ADDENDUM NO. ONE
NCSB -FBMS

To the Plans and Specifications for:
Nassau County School Board – Project No. 98110-031
Fernandina Beach Middle School Kitchen / Dining Remodeling and Campus
Renovations/Enhancements

Date: October 15, 2018

SECTIONS

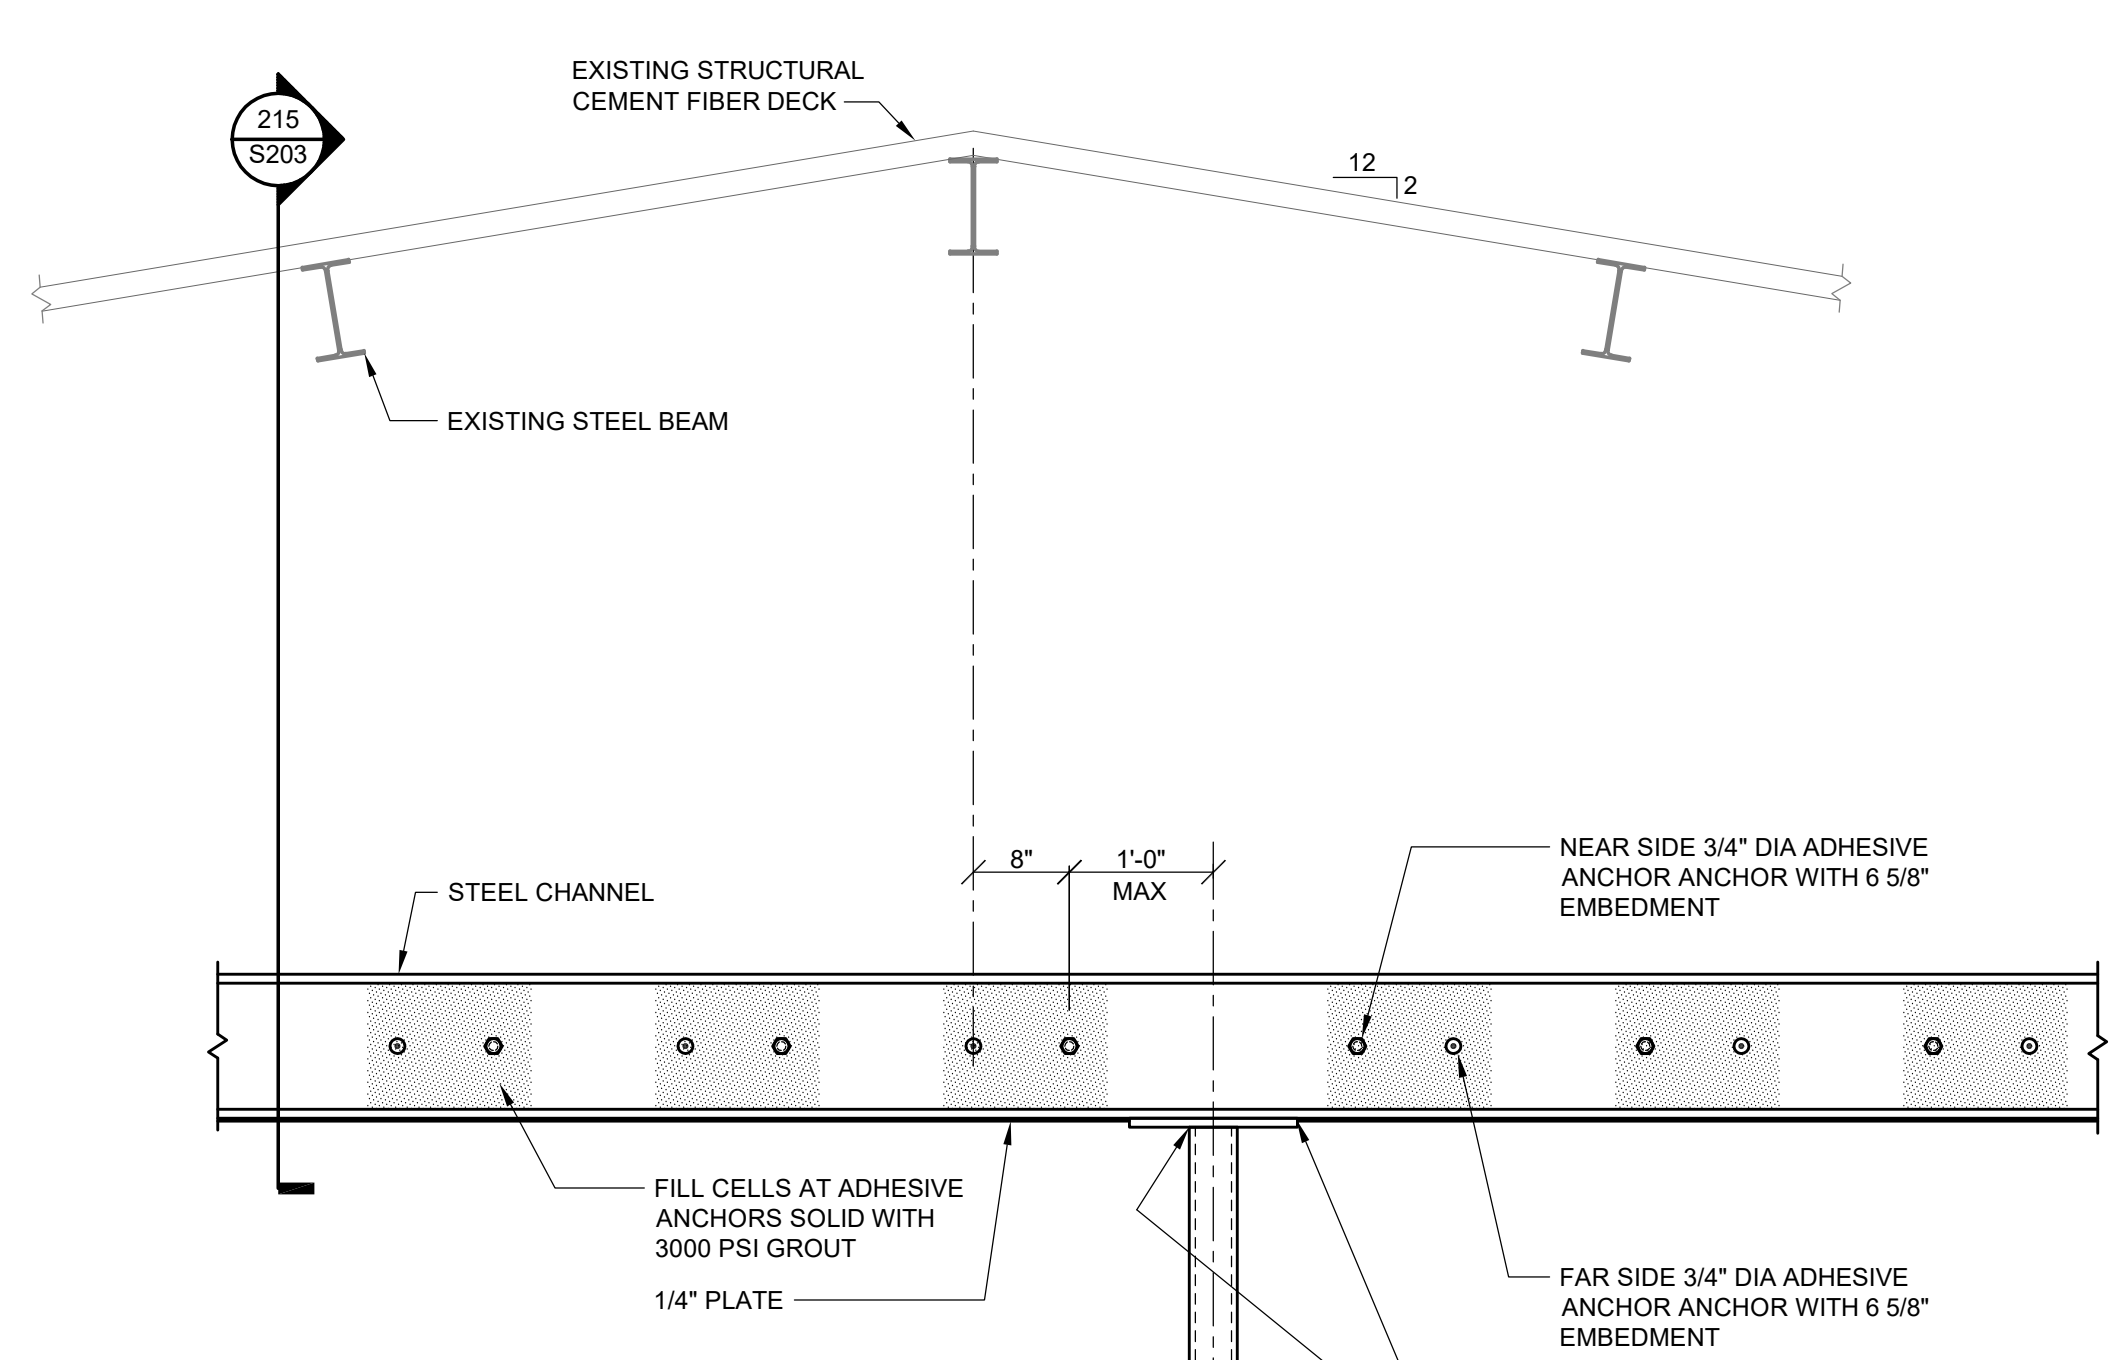
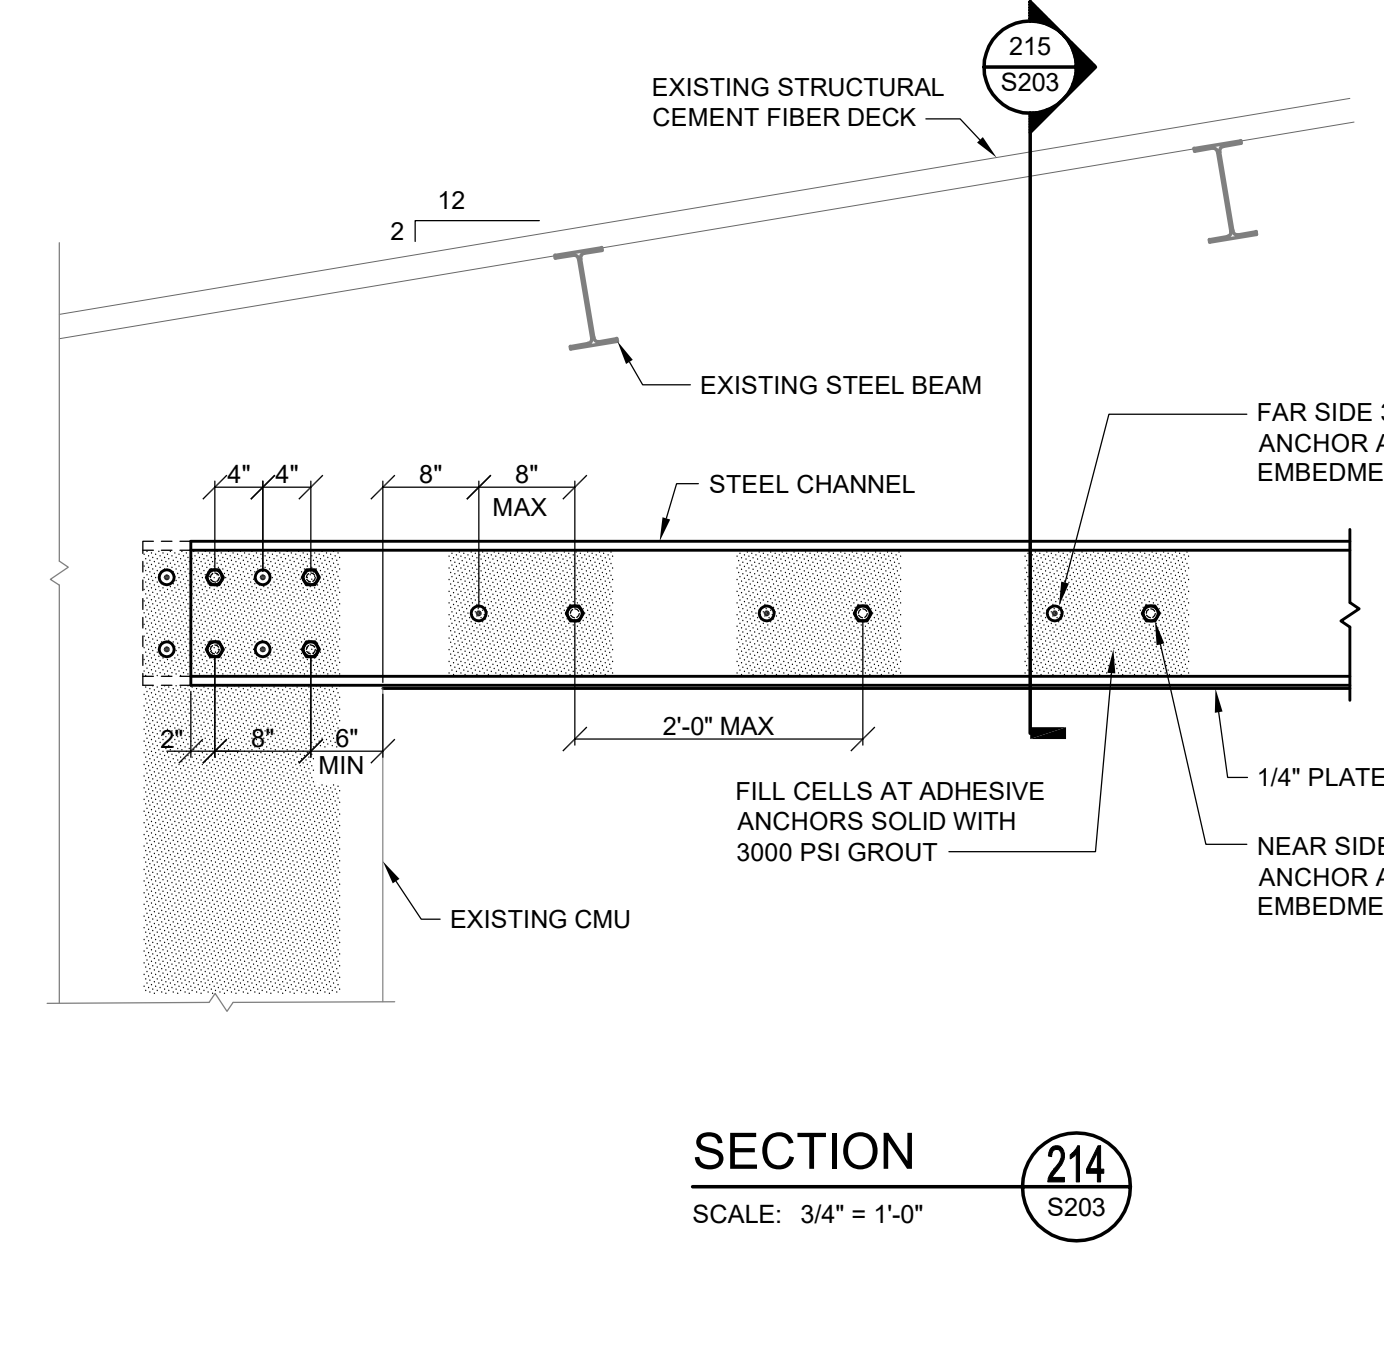
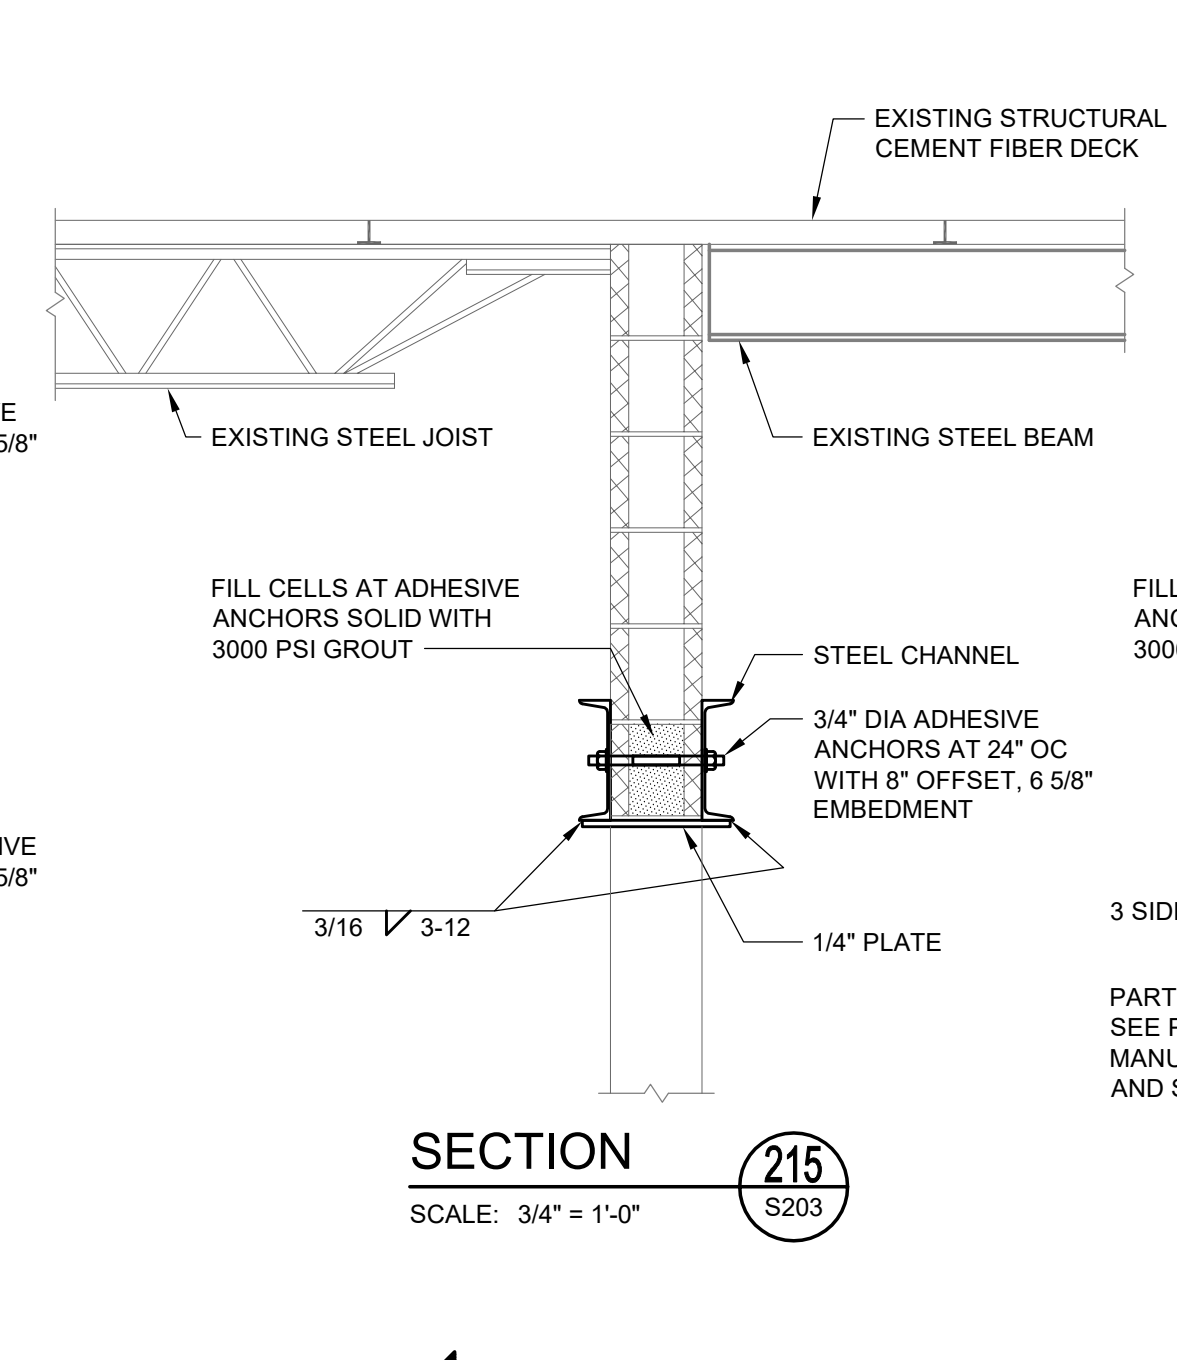
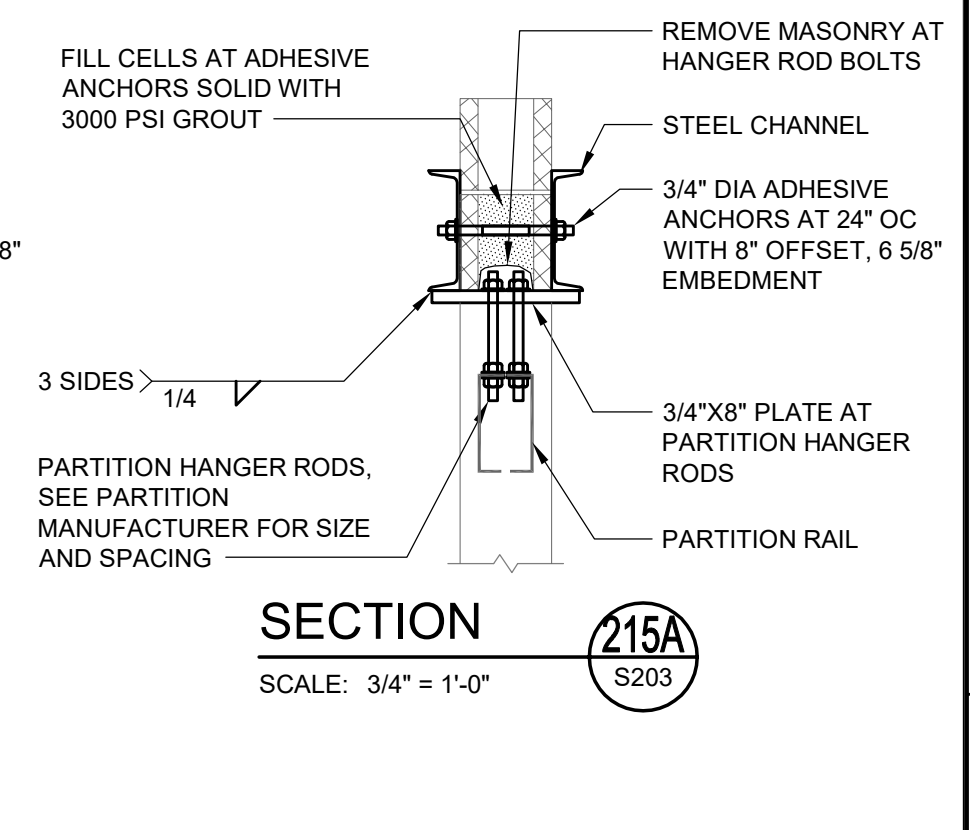
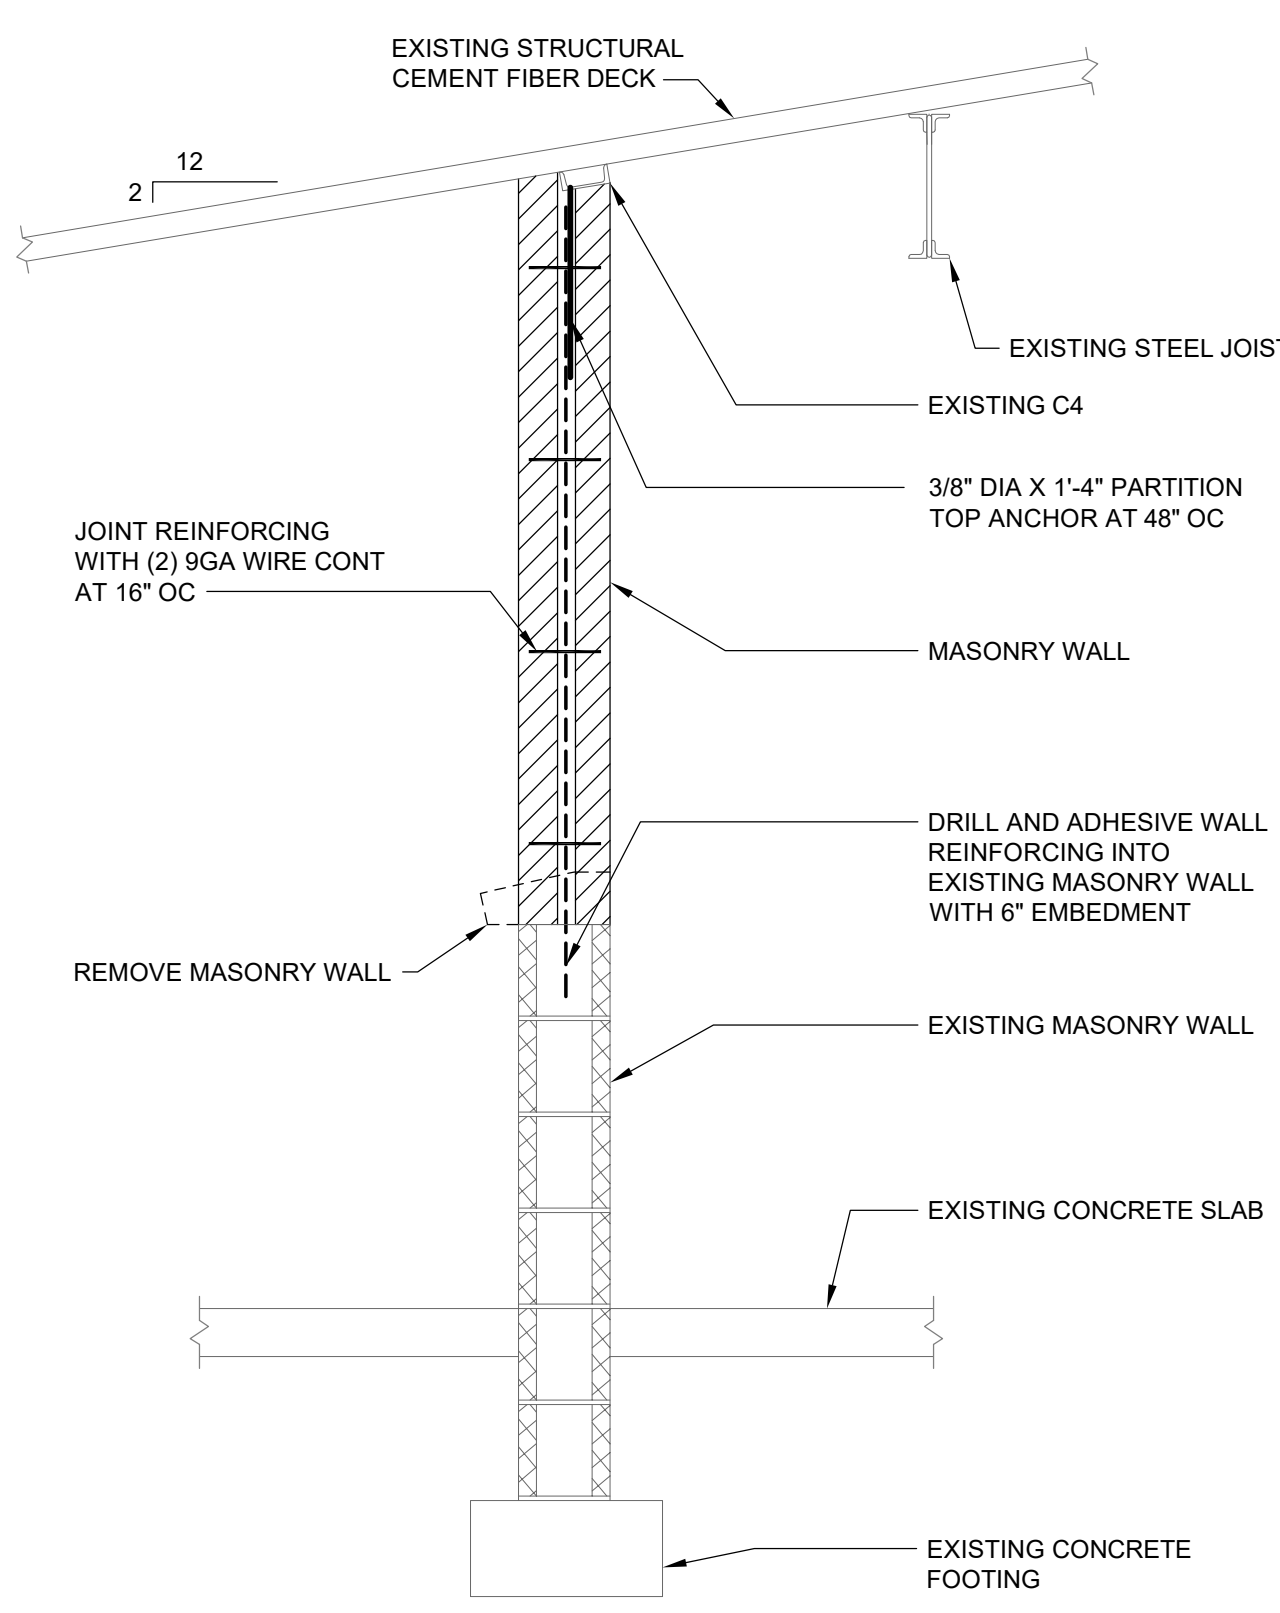
Refer to attached Sheet S102 and S203for changes to the Structural Drawings.
